CODE COMPLIANCE CERTIFICATE

Consent No: 160475

Building Work			
Building Consent No:	160475	Issued by:	Kapiti Coast District Council
Project Description:	New single level shadow clad dwelling

Date:	9 August 2016	Instruction No:	01	Job No:	40735
Authorised By:	Geert van de Vorstenbosch				
Principal:	David Reid Homes (Kapiti) Ltd				
Contractor:	David Reid Homes (Kapiti) Ltd				
Contract:	2 Kanuka Close, Waikanae	Number of pages incl this sheet:	02

FOUNDATION PLAN

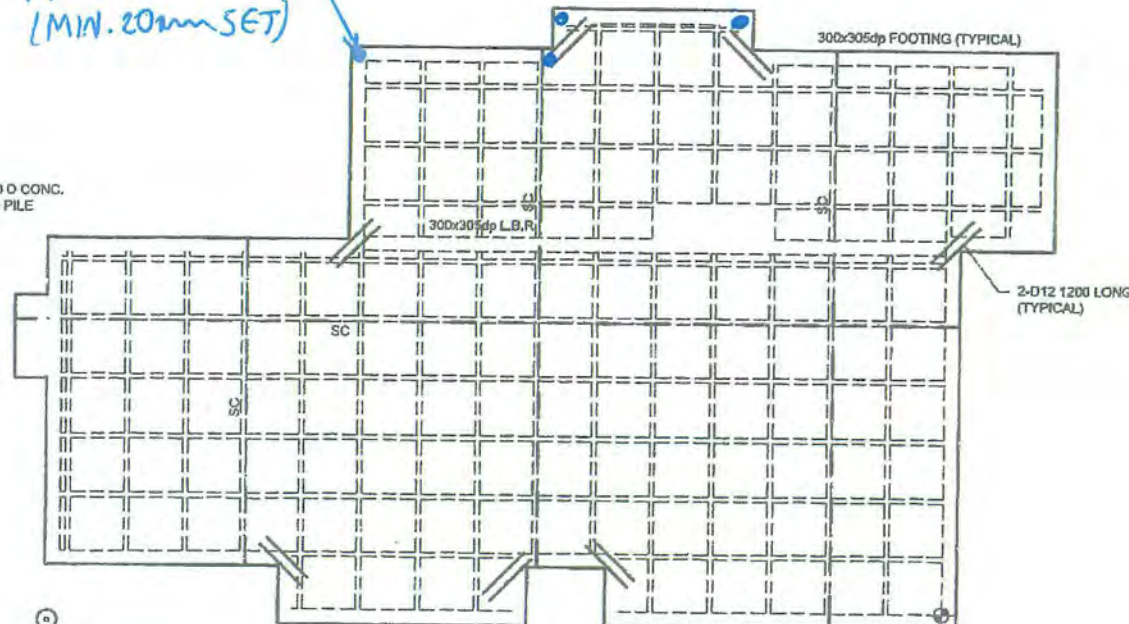
Following a site visit on 9 August 2016, the Ribraft slab is to have 150Ø SED H5 treated driven timber piles installed under it in accordance with the revised Foundation plan (refer attached).

REVISED BRACING PLAN
SK1 (REVISION 1)

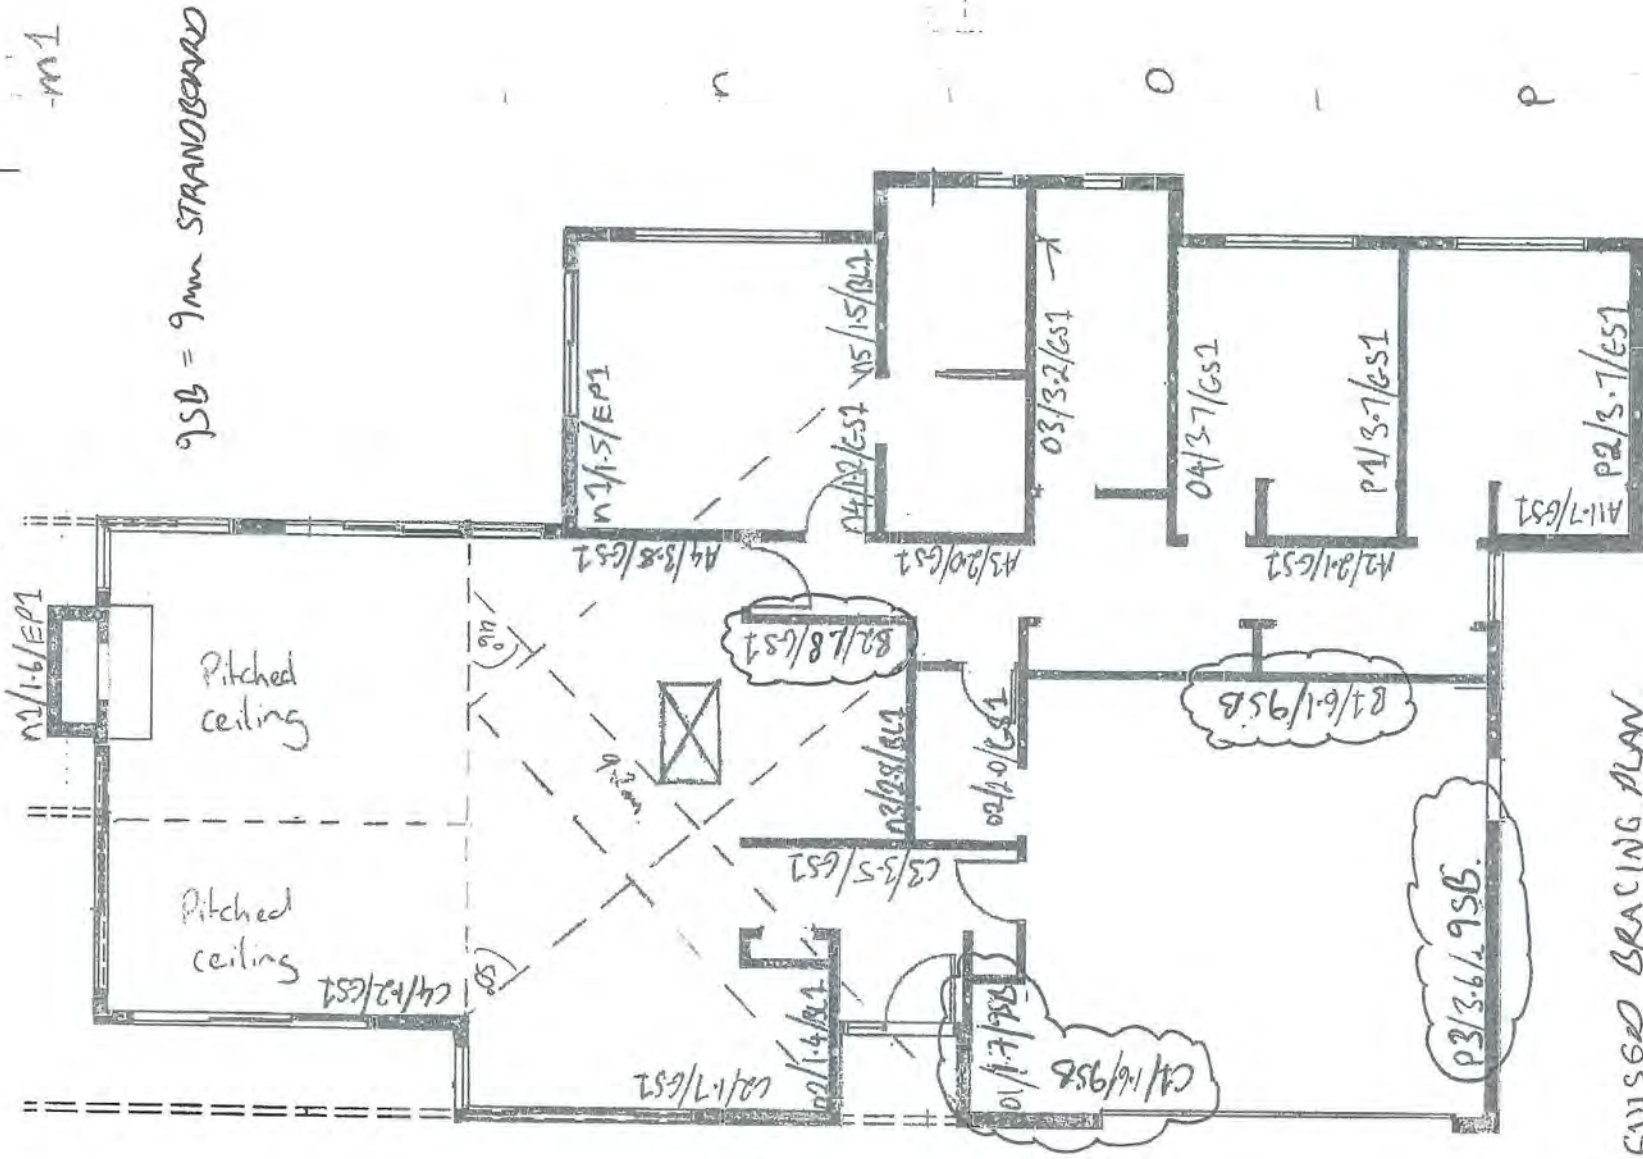
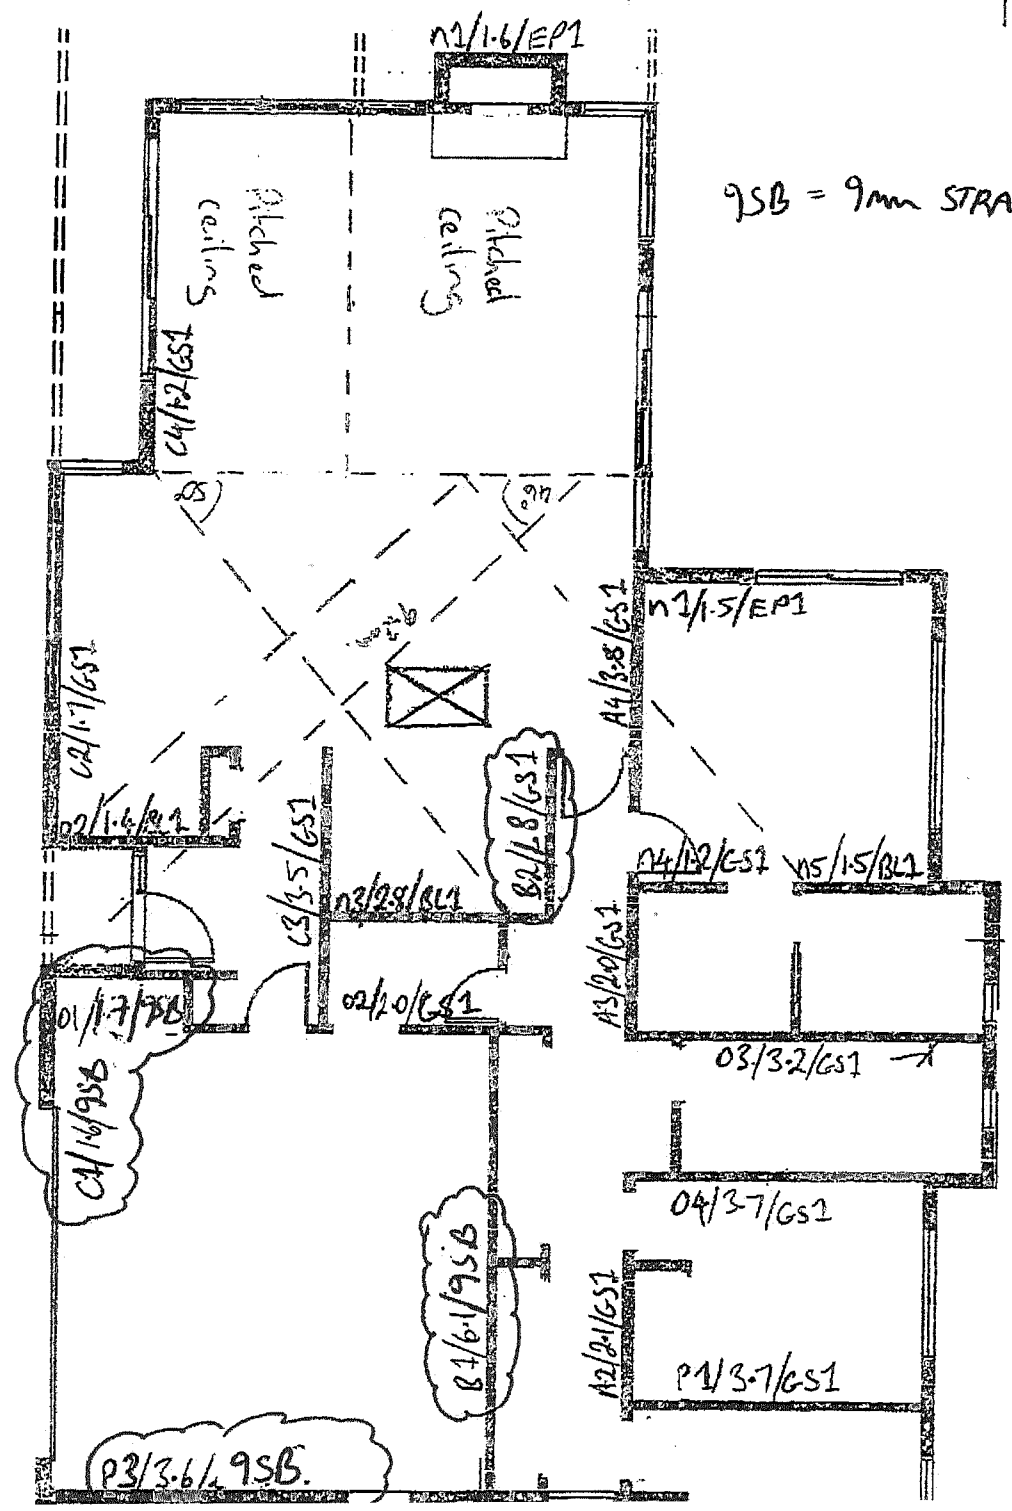
2.01 **Revised Bracing**

Inspection Element	Status
General	Pass
engineer has added extra bl bracing	
Confirm additional information/amended plan	Pass
new bracing plan provided
